ERI Huron Main Street
ODOT PID No. 118507
Federal Agreement No. 43204
City of Huron

ADDENDUM #02

CONCRETE SHARED USE PATH
NOT TO SCALE

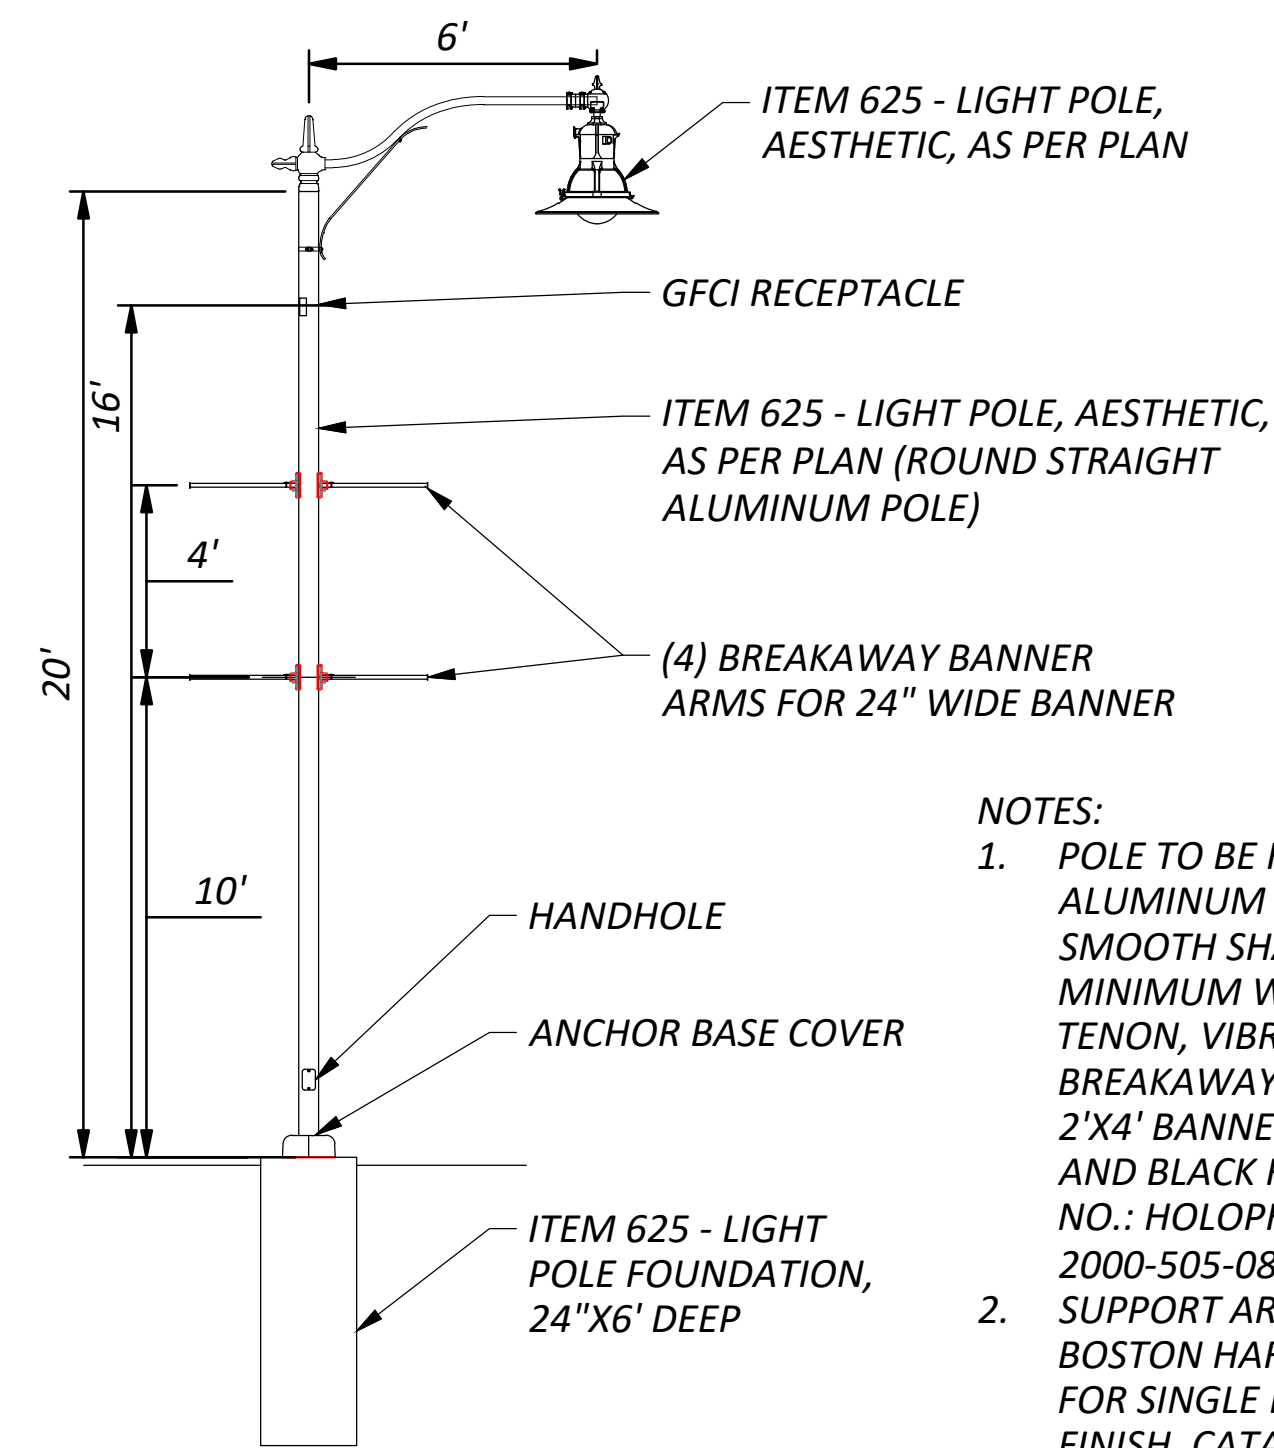
3. Question: What is the fiber dosage in the 6" shared use path? It is not on the detail. It also does not show expansion spacing on this item.
 - a. **Engineer Response: Fiber dosage is 3lb/cy note has been amended in the plans to include. Expansion spacing is per the concrete walk detail notes and specifications.**

1. 1/2" EXPANSION JOINTS AT ALL CURBS, WALKS, WALLS AND OTHER FIXED OBJECTS.
 2. CONTROL JOINT-5' O.C. MAX. OR AS SHOWN ON DRAWINGS.
 3. CROSS SLOPE AT 2.00% MAXIMUM TO MEET ADA REQUIREMENT.
 4. MEDIUM BROOM FINISH.
 5. USE MICROFIBER AT A MIX DOSAGE RATE OF 3 LB/CY.
 6. CONSTRUCT CURB RAMPS IN ACCORDANCE WITH ODOT SCD BP-7.1 AND ADDITIONAL DETAILS CONTAINED HERE.
- * ALL COSTS FOR ITEM 608 - 4" CONCRETE WALK, AS PER PLAN AND ITEM 608 - CURB RAMP, AS PER PLAN SHALL BE INCLUDED IN THE UNIT COST BID (INCLUDING ALL ITEMS SHOWN). ALL REPLACEMENTS TO BE A MINIMUM OF 4' WIDE IN LENGTH (AS APPROVED BY THE ENGINEER) OR TO THE NEAREST JOINT.
